Ref. Refuse Bins Shore Rd Swanage.

Ref. Refuse Bins Shore Rd Swanage.

Litter bins in Swanage

Alternative

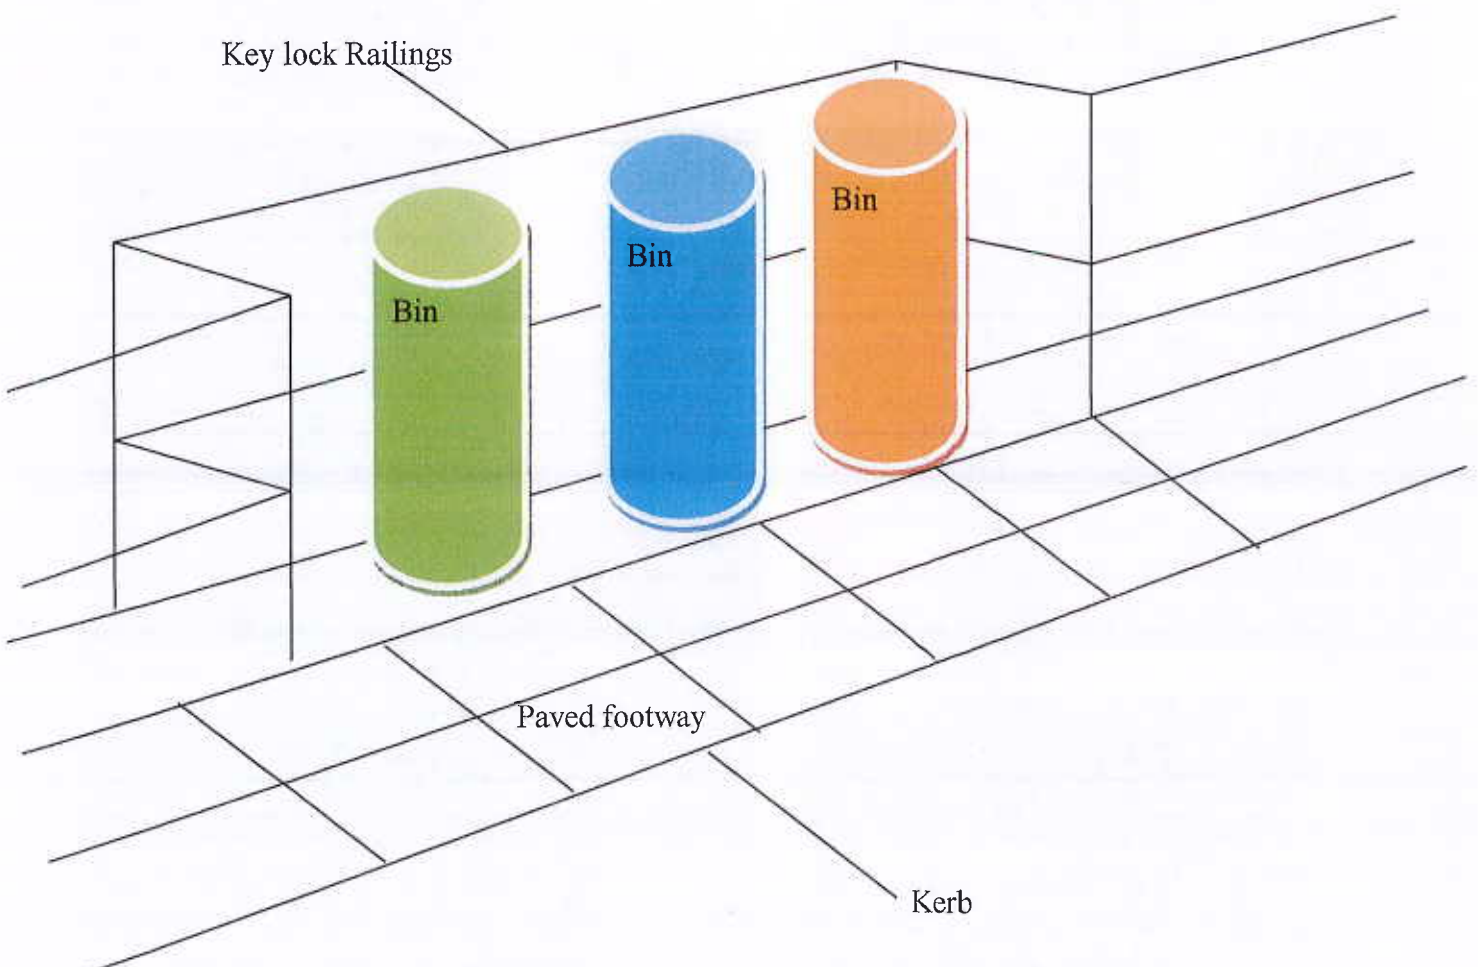
I have enclosed photos to show the issue and sketches as possible solutions, this would keep the bins located in place and cause less inconvenience to all.

These installations could be placed at the access points to the beach all along the seafront.

In places the new bins have reduced the available width of the footway to 800-900mm especially where they have been placed adjacent to lamp columns and parking meters causing a chicane effect, see enclosed photographs.

May I suggest a return to the old bins, which were less intrusive or as an alternative construction of on road islands as enclosed sketch, where bins and parking meters could co exist without causing footway obstruction.

I have discussed your letter with Mr Mike Moon Operations Manager at the Dorset Waste Partnership. He has advised me that he will provide you with a response in due course. I understand there operational reasons as to the why the bins are located where they are and he will be able to provide a far better overview of the reasons than me.
